Item Name: Crosstube Turning Detail

DART AEROSPACE LTD		Work Order:	96772
Description: Crosstube Assembly (205/212/412 High Fwd)		Part Number:	D212-664-141
Inspection Dwg: D212-664-141 Rev: D		Page 1 of 2

DRAWING NO. D212-664-141	TITLE XTUBE ASSY (205/212/412 HI FWD)	REV. D	DART AEROSPACE LTD ENGINEERING ORDER		D.E.O. NO. D212-664-141-D-1	SHEET NO. SHEET 1 OF 2	SCALE NTS
DRAWN	CHECKED <i>UP</i>	MFG. APPR. <i>ER</i>	APPROVED <i>MP</i>	DE APPR. <i>MP</i>			
DATE 11.04.07	DATE 11.07.11	DATE 11.04.12	DATE 11/04/12	DATE 11.04.12

ADD AN INSPECTION WINDOW TO UNDERSIDE OF CROSSTUBE.

**D212-664-141/-141B
ASSEMBLY DETAIL**

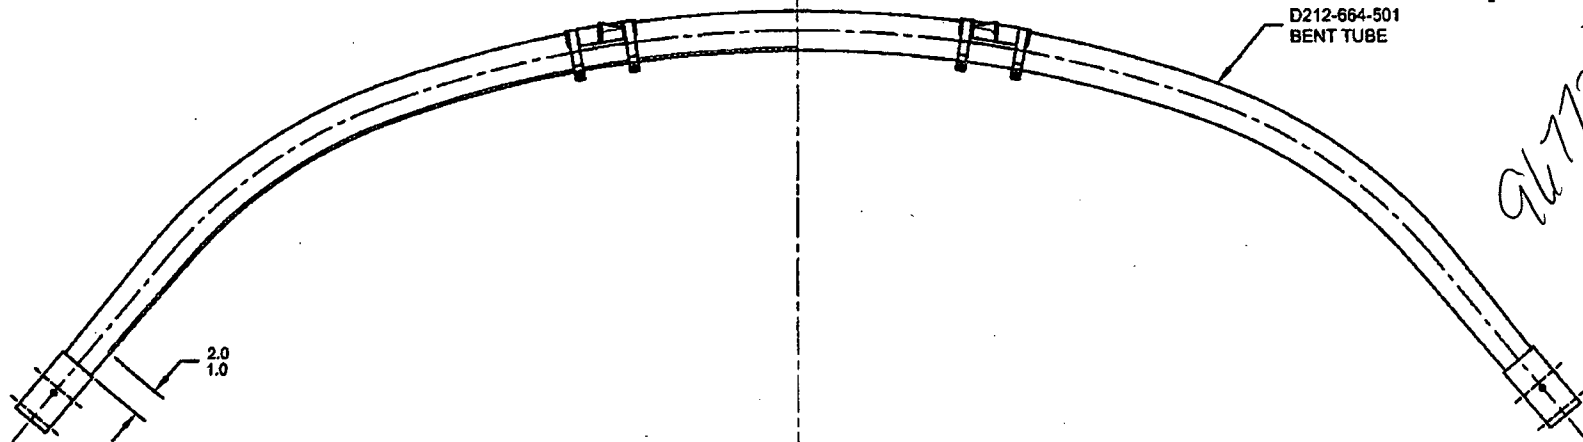
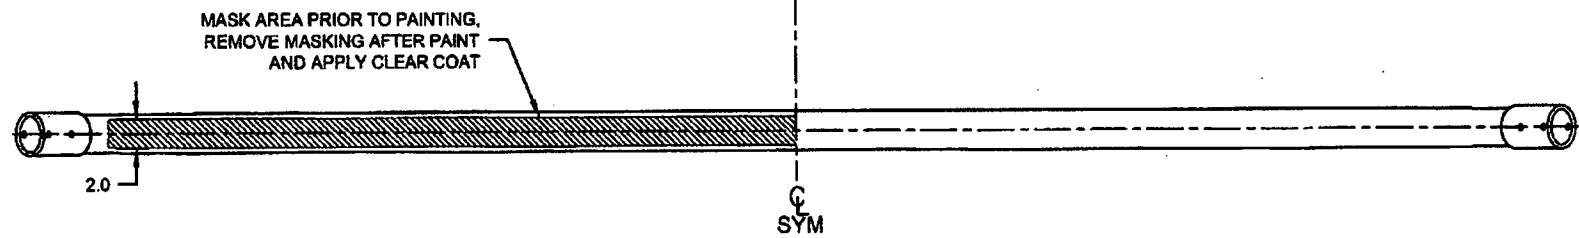
PURPOSE:

NOTES 2 OF SHEET 1 IS AMENDED AS FOLLOWS:

- 2) FINISH: CHEMICAL CONVERSION COAT PER DART QSI 005 4.1
PRIME INSIDE AND OUTSIDE PER DART QSI 005 4.2
MASK UNDERSIDE OF CROSSTUBE AS SHOWN (HATCHED AREA) AND
PAINT OUTSIDE PER DART QSI 005 4.2
REMOVE MASKING AND APPLY CLEAR COAT

- 2) FINISH: CHEMICAL CONVERSION COAT PER DART QSI 005 4.1
PRIME INSIDE AND OUTSIDE PER DART QSI 005 4.2
PAINT OUTSIDE PER DART QSI 005 4.2
